ADDENDUM

Project Name:	Project Name: Enclosed Commons	Addendum No.:	Four (4)
	Owner's Name: Grady ISD	Date:	3/23/10
	Street Address: 3500 FM 829.	Project No.:	07031.7
	City, State Zip: Lenorah, Texas 79749

SUPPLEMENTAL DRAWING NO. SD-21

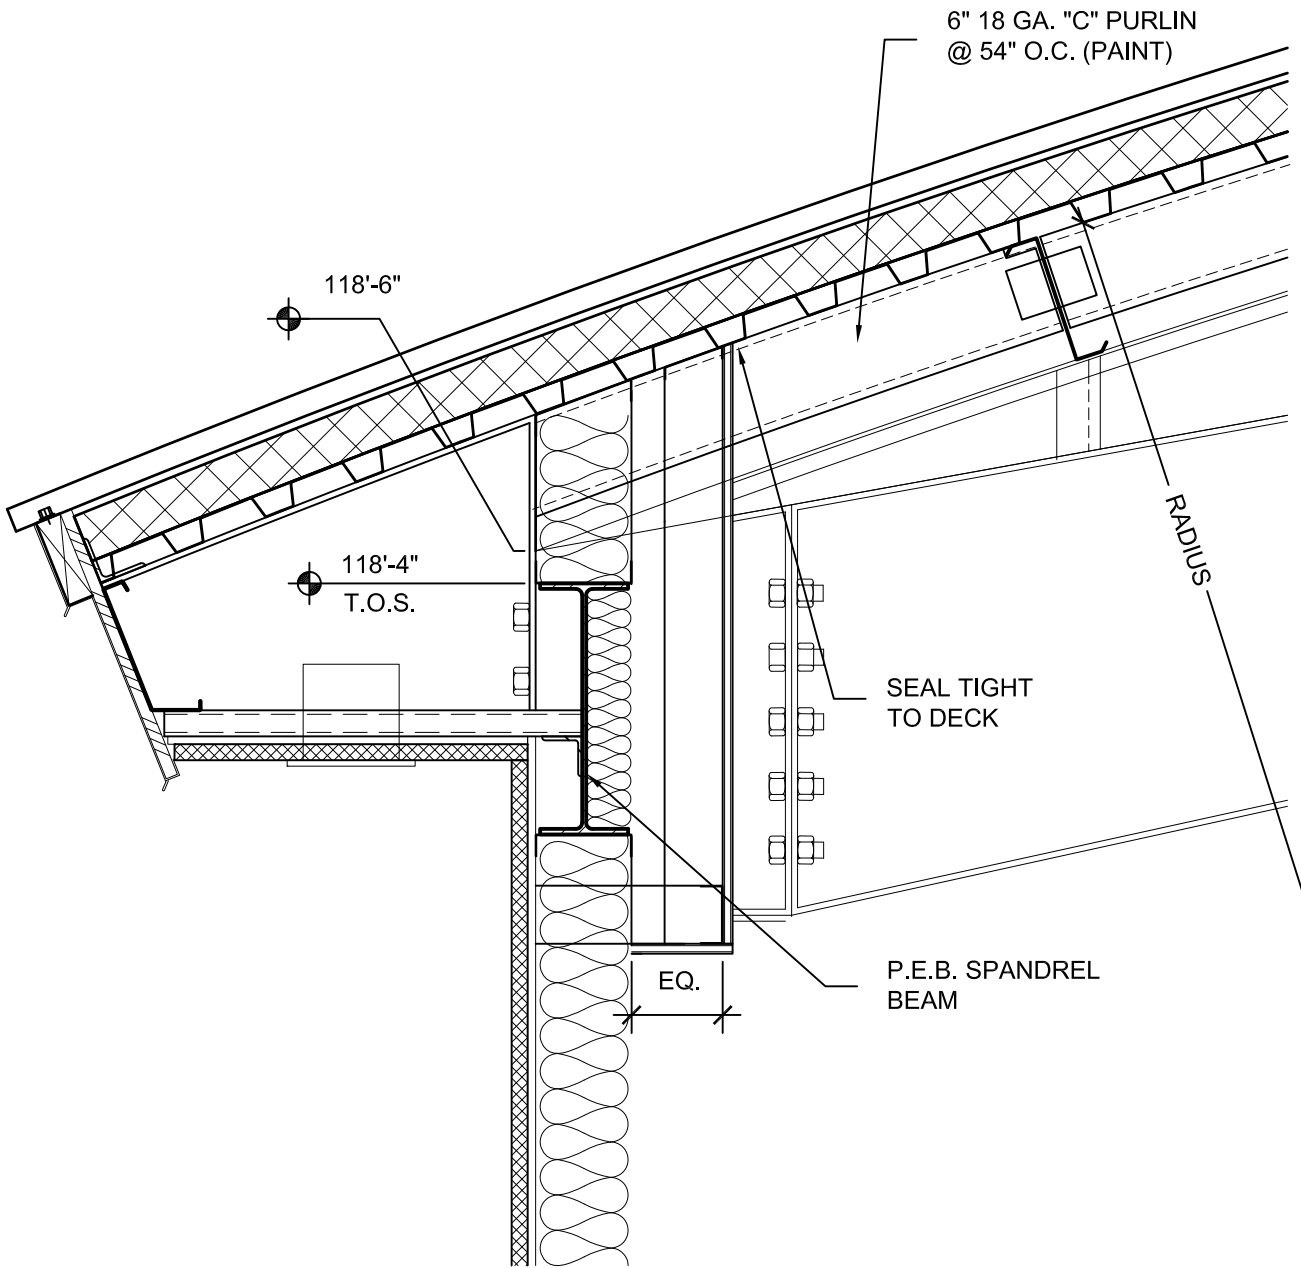
Item No. One: For clarification purposes acoustical metal deck to be installed parallel to "Z" purlins. Metal building supplier to provide 18 gauge, six inch "C" purlins bent to radius as indicated in plans. Attach purlins with clips perpendicular to Z purlins at 54" o.c, with tops flush. Space to allow 4 equal spaces at 18'-0" metal building bays and 6 equal spaces at the 27'-0" metal building bays. Spacing at end wall bays not to exceed 5'-0". See attached Supplemental Drawing SD-21.
